VENTURE ON VENETUCCI SITE DEVELOPMENT PLAN ~~AND FINAL PLAT~~

LETTER OF INTENT

PPR2444

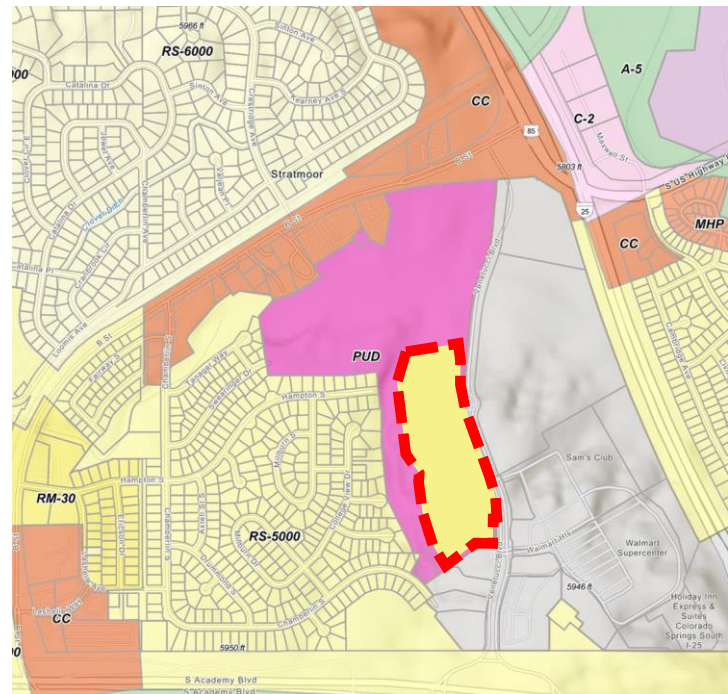
is it restaurants? isnt sams club walmart to the east?
